ONE SYDNEY HARBOUR

R4B SECTION 4.55 MODIFICATION APPLICATION (SSD 6965 MOD 7 AND SSD 8892218 MOD 5) October 2022

Residential Building R4B - Development Consent

R4B ground floorplan at basement carpark entry with proposed pavement signage zone

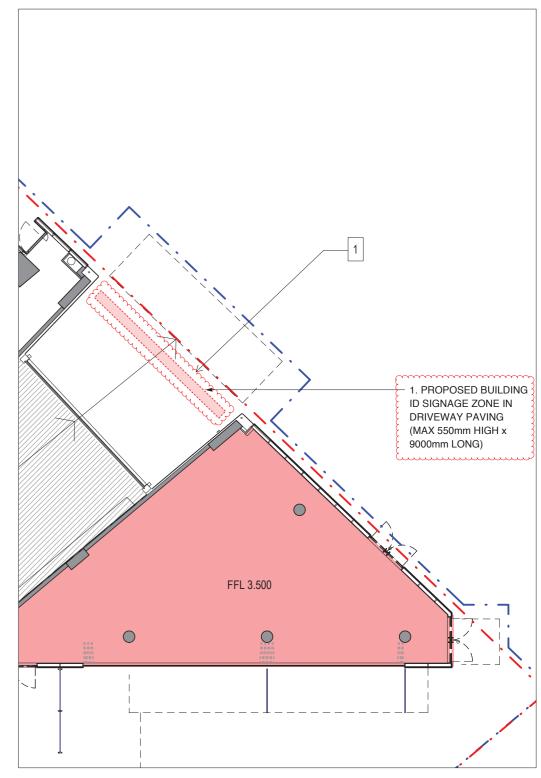
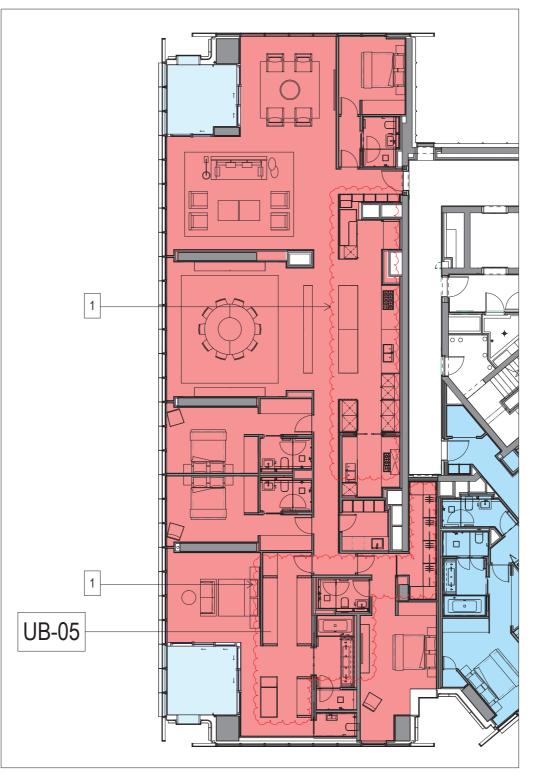
Addition of a recessed metal lettering building identity entry sign within the natural stone paving of the driveway is proposed. Introduction of a sign at the main entry for residents returning and visitors arriving in cars will increase amenity by positively confirming the shared basement entry as belonging to all three of the towers.
